**ADDENDUM
NO. 01**

Edwardsburg Public Schools – Middle School and High School Mechanical Upgrades

ADDENDUM NO. 2

PROJECT: **Edwardsburg Middle School – Mechanical Upgrades**
69410 Section St.
Edwardsburg, MI 49112

DATE
JANUARY 16, 2026

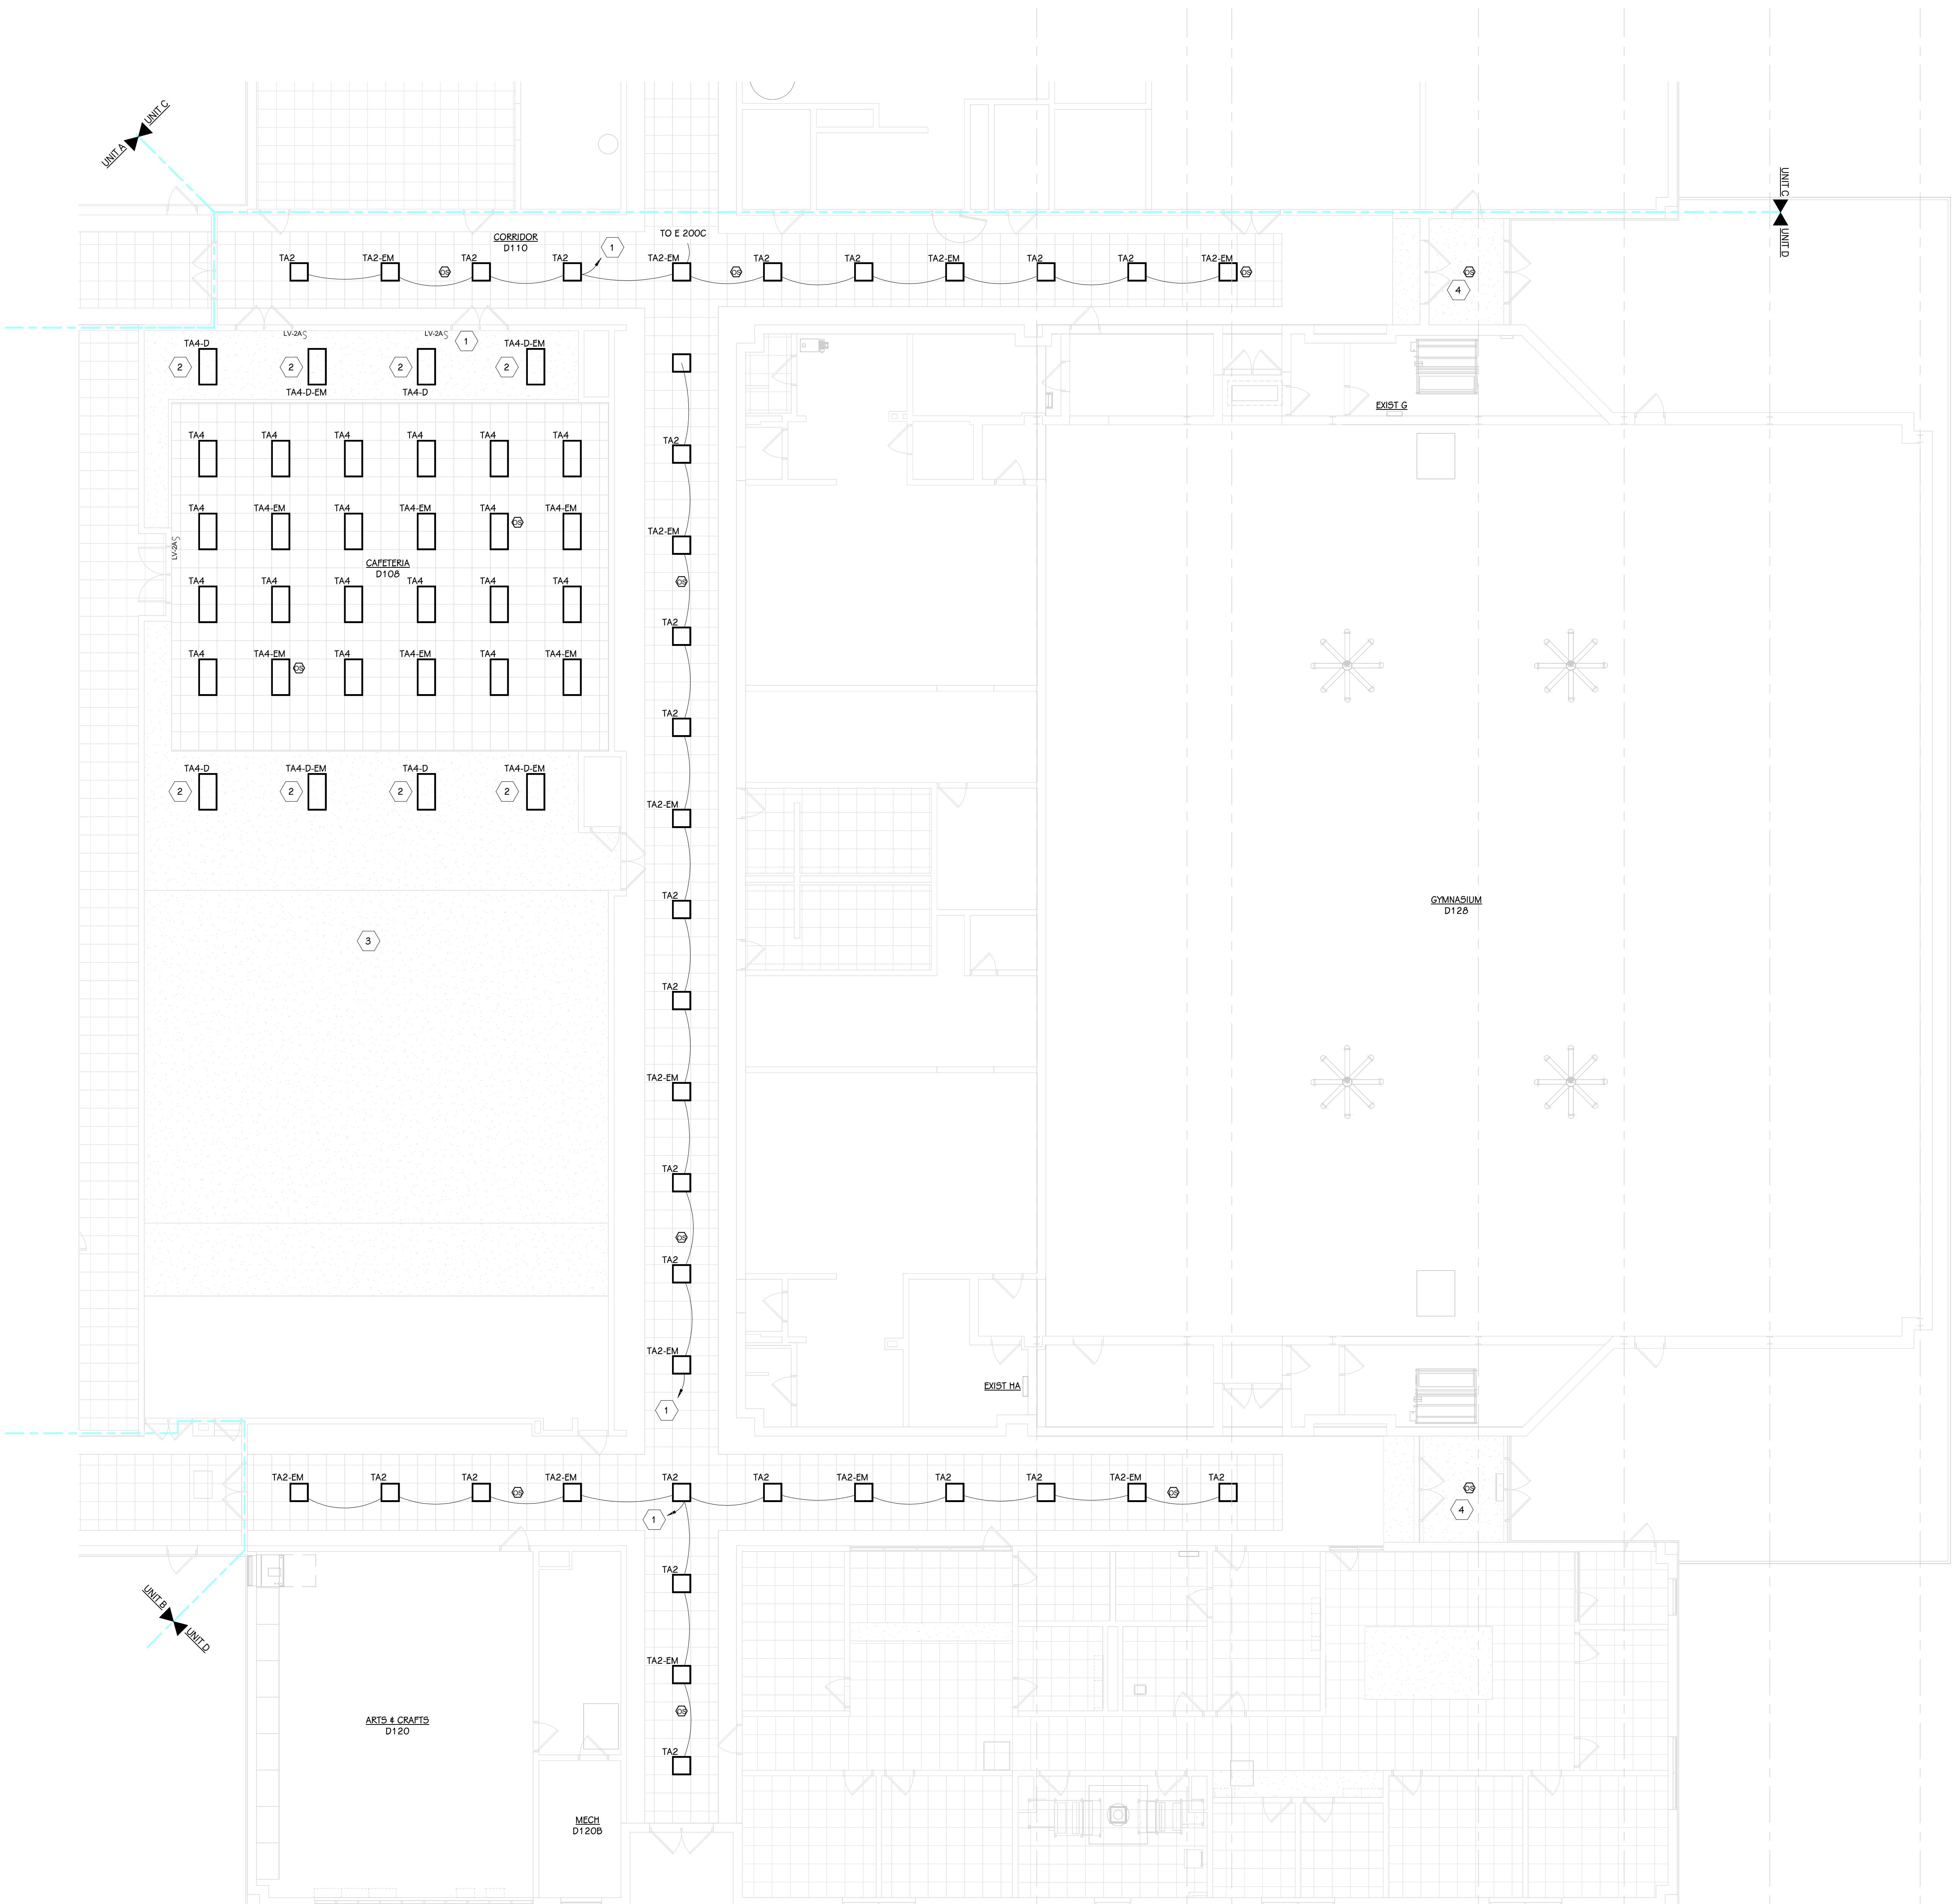
E 201A, E 201B, E 201C, and E 201D – Added new lighting drawings.

1 DUAL ZONE DIMMING CONTROLLER

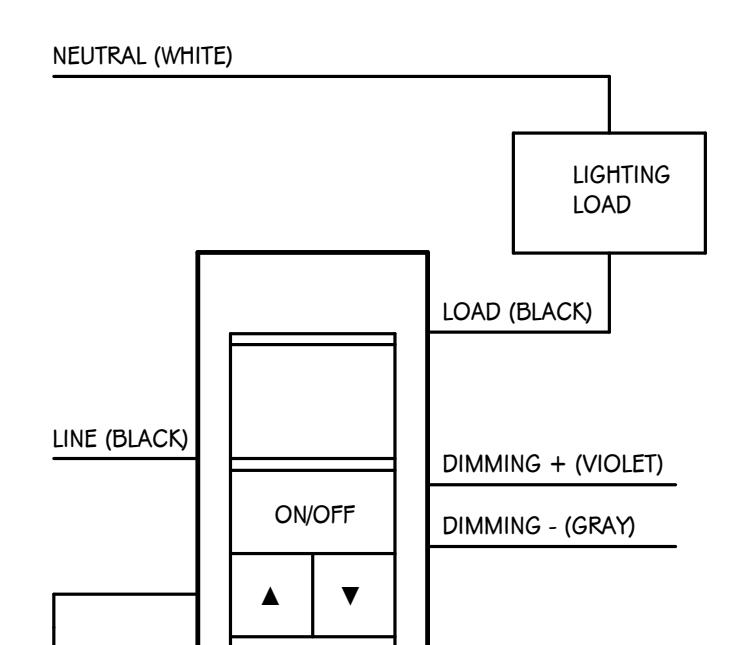
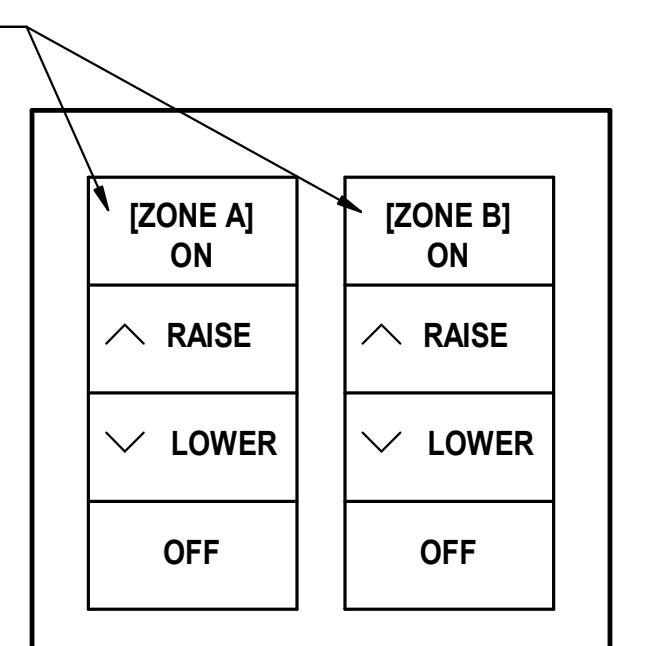
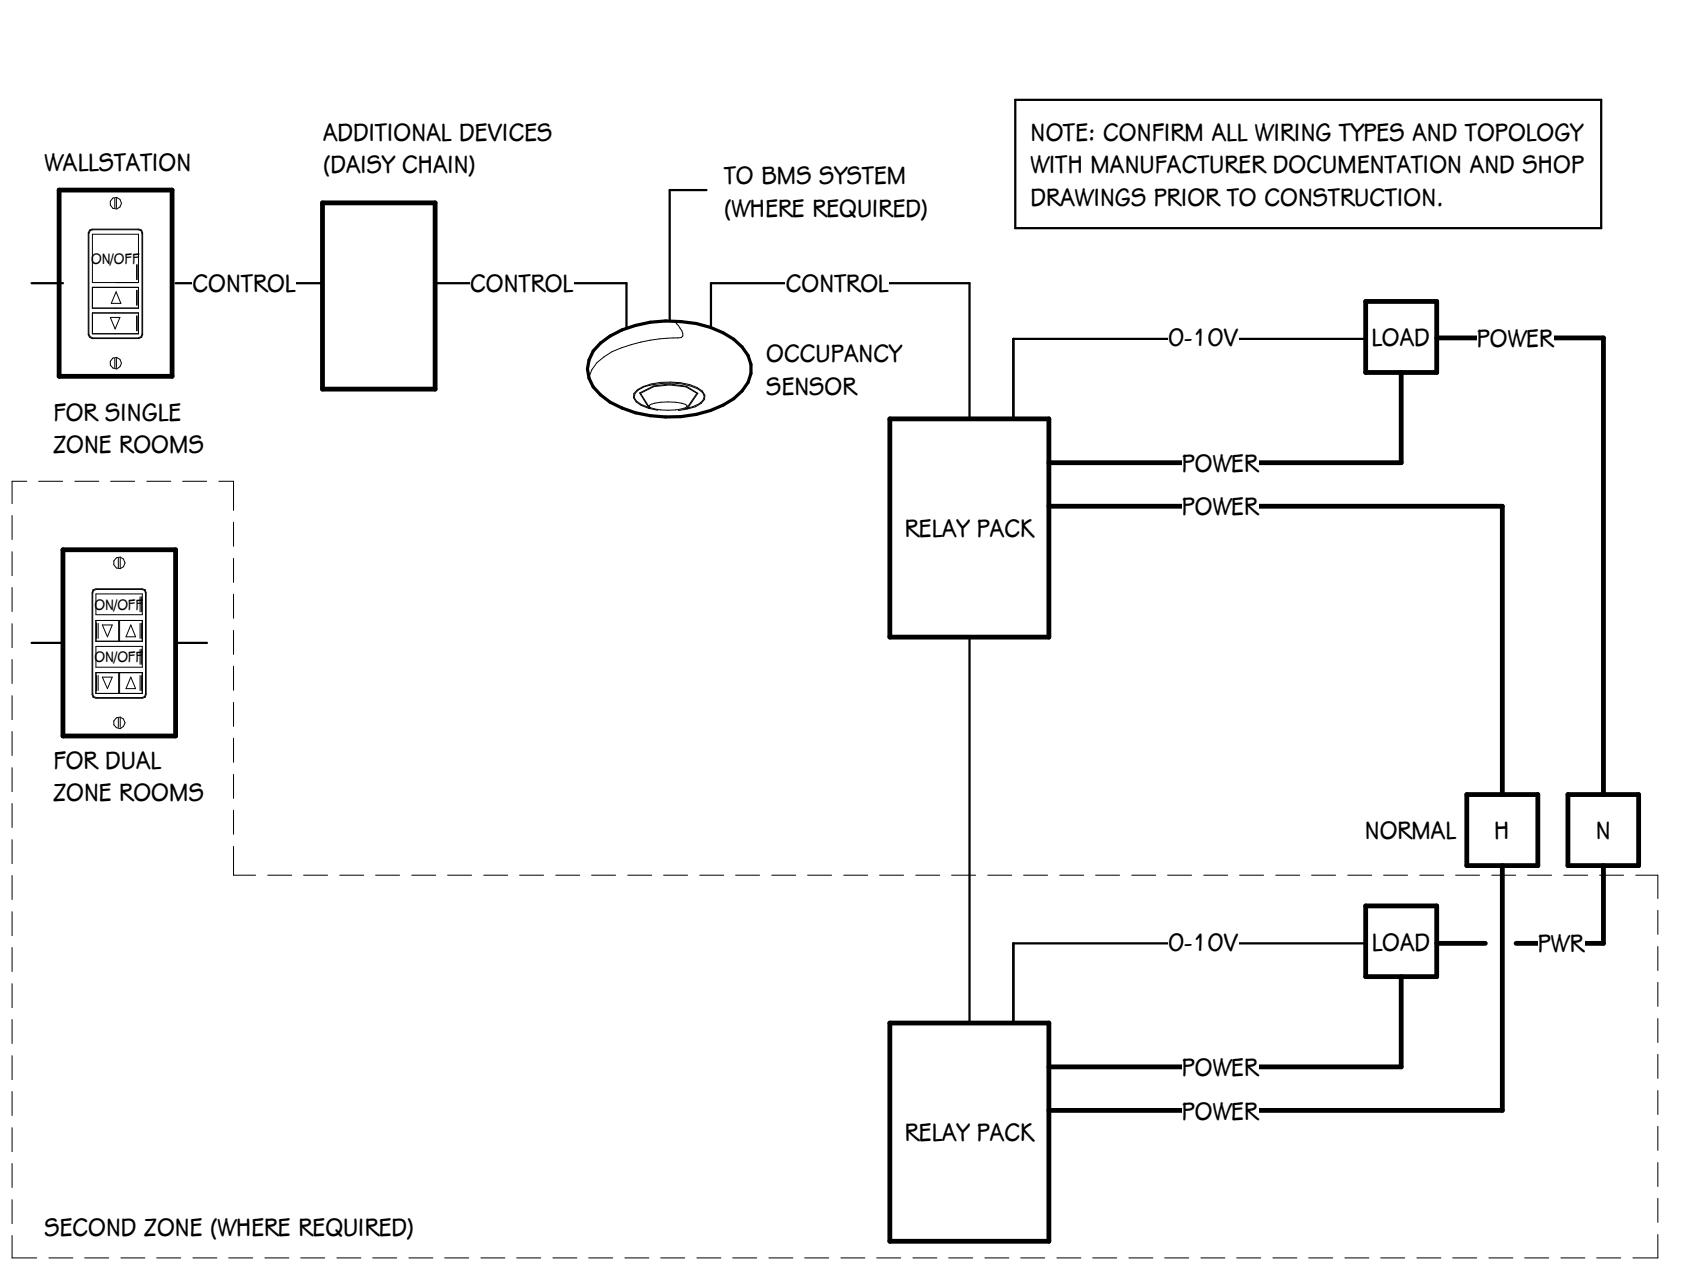
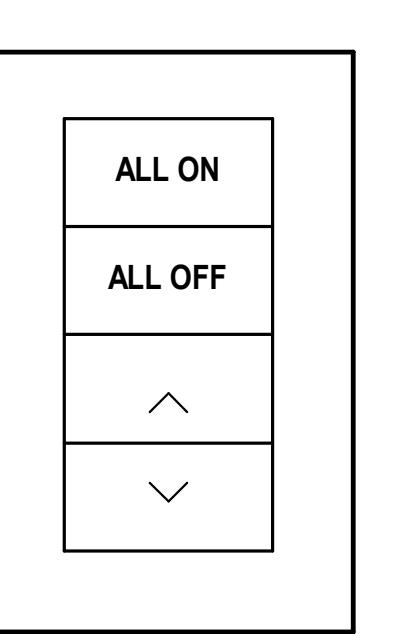
E 420 – Added new lighting schedules, details, and controls drawing.

SHEET NUMBER
E 420
21-201.061

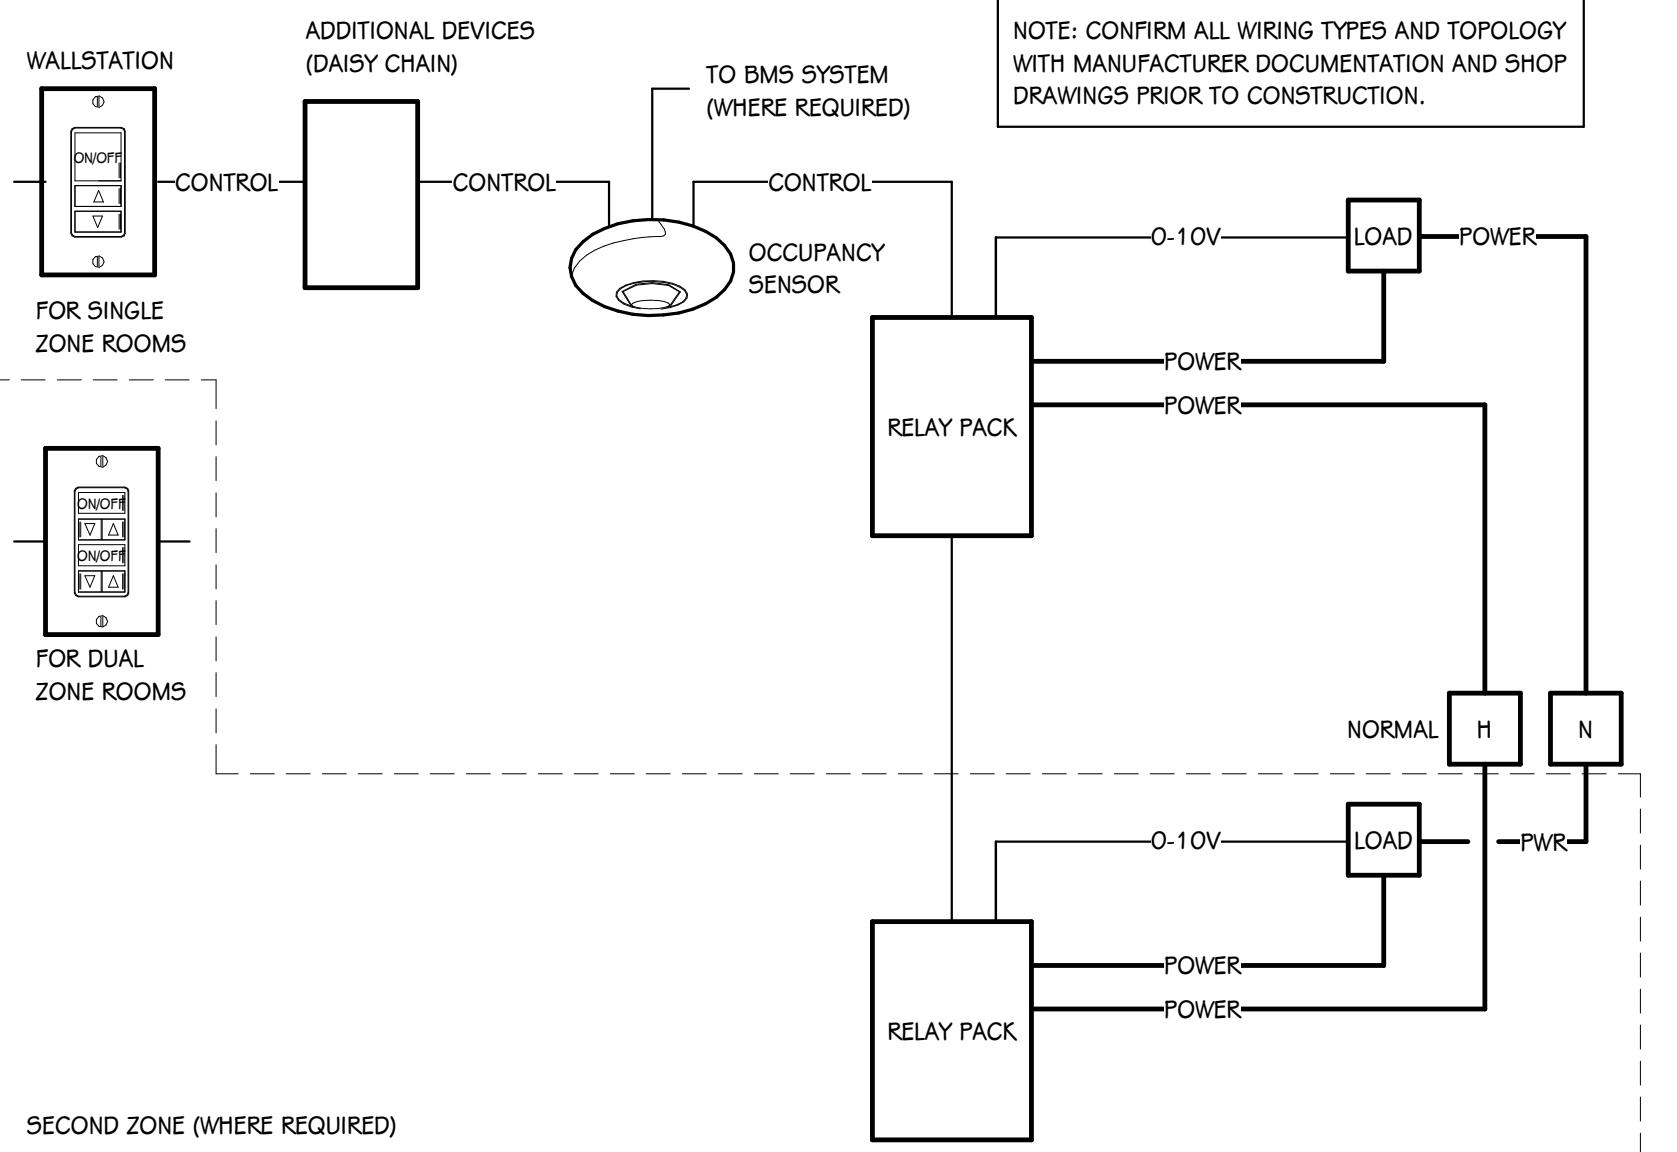
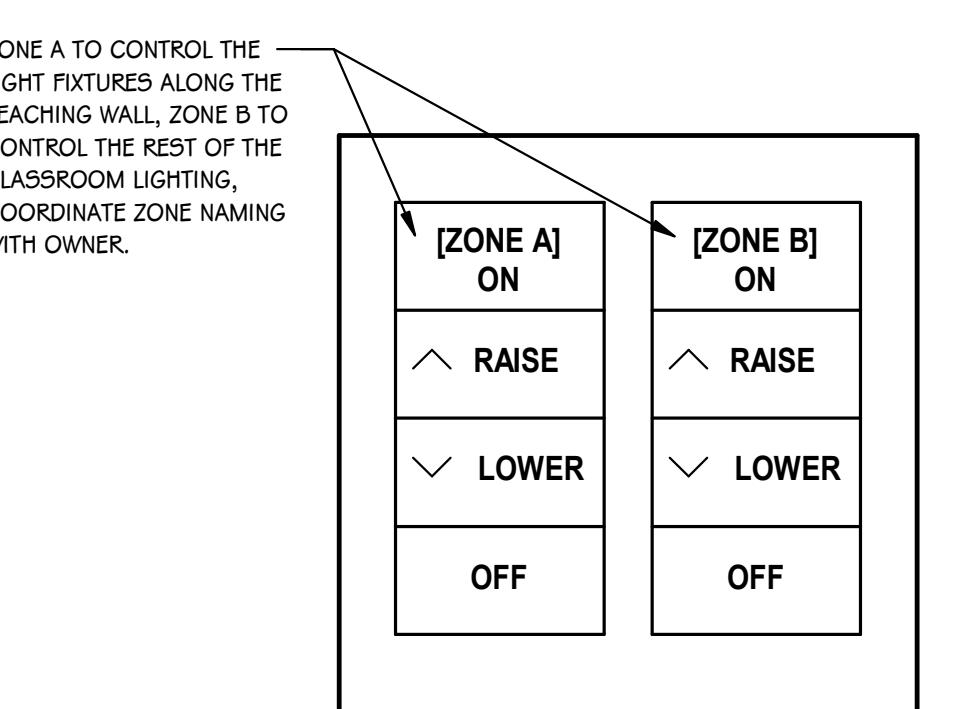
E 420 – Added new lighting schedules, details, and controls drawing.
